Access Compliance Report

Public Rights-of-Way

(Curb Ramps)

Intersection ID: 10035049	Main Street: PROVIDENCE_RD	Cross Street: N/A	Location: N
ADA ID: 0E83368986C4	Ramp Type: Directional1	Initial Pass/Fail: Fail	Overall Compliance: No
Severity Score: 1.25			
Codes/Mitigation Info/Possible Solution		Field Measurements/Component Compliance

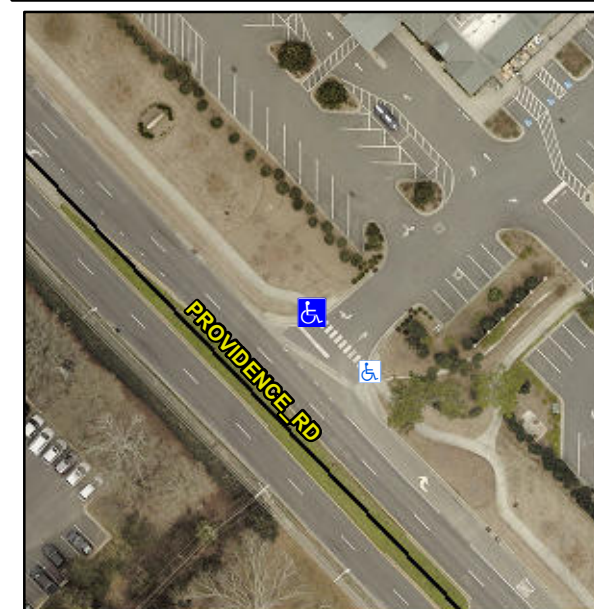
Remove & Replace Entire Ramp.

R304.5.3
